APPROVED
 Limited building only review
 Permit holder responsible for full compliance with the code

Revised 5/18/20

187 Castlebow Dr

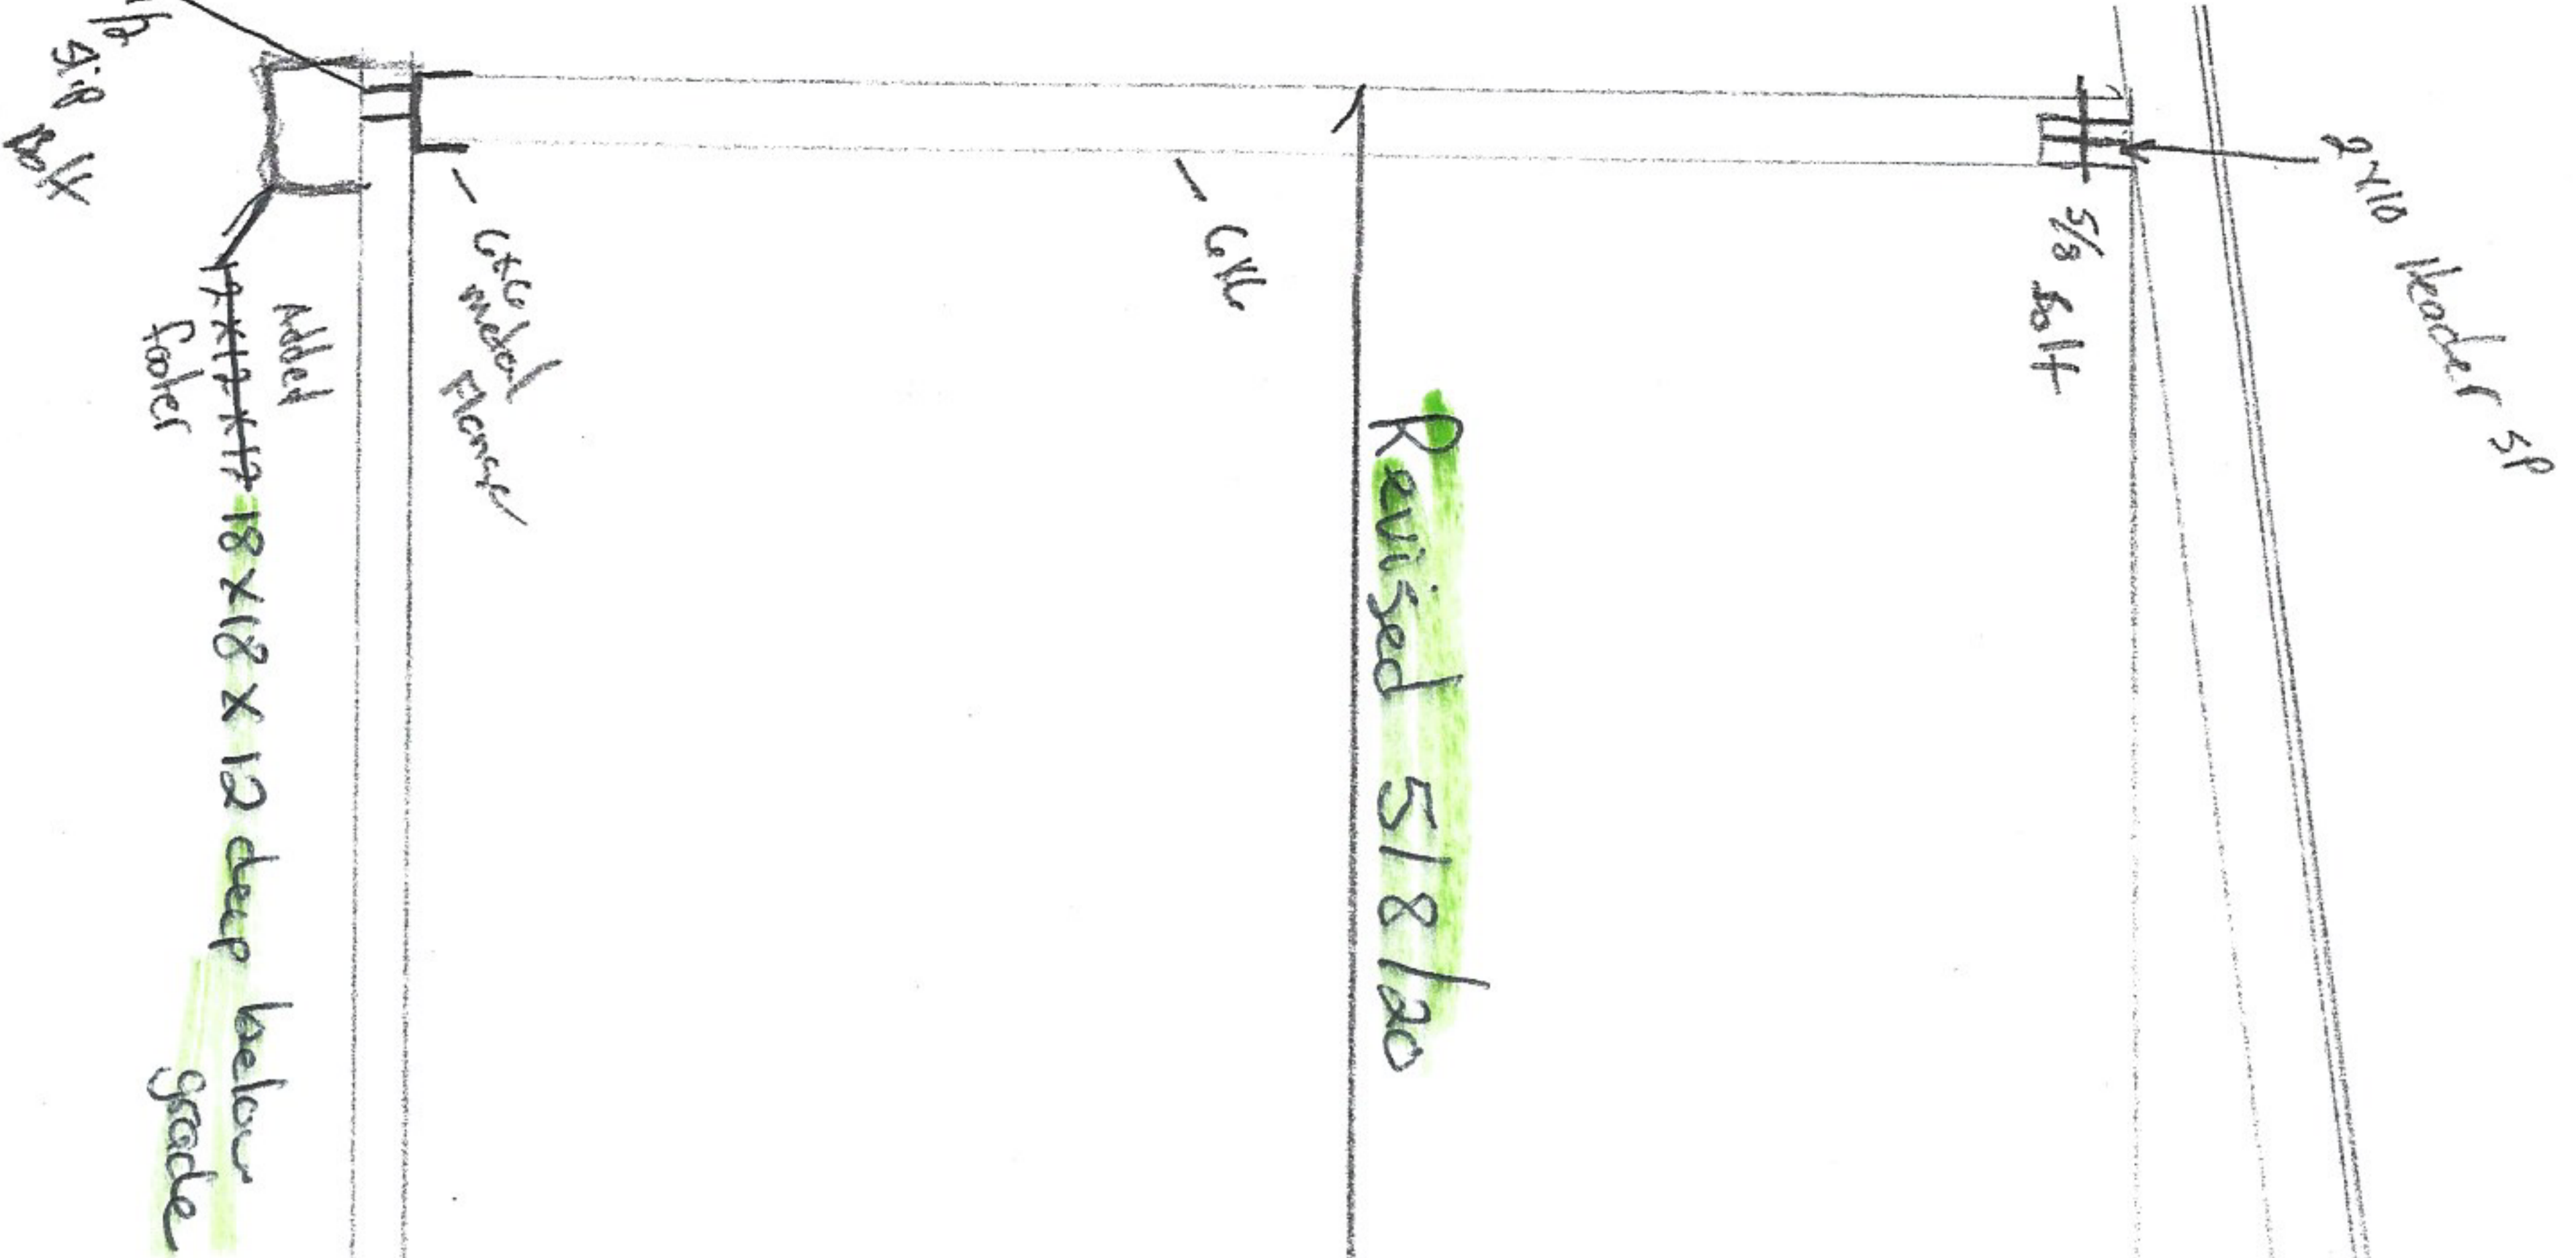
Center support
 header double LVL 1 3/4 x 14

Header double 2x10 SP

Existing wall
 supported by 3 2x4 post
 in wall

Revised 5/18/20

Double 1 3/4 x 14 LVL
~~2 1 3/4 x 14 FVL~~
 for a 3 3/8 x 14

Added 18x18x12 deep below grade footer

Added 18x18x12 deep below grade footer
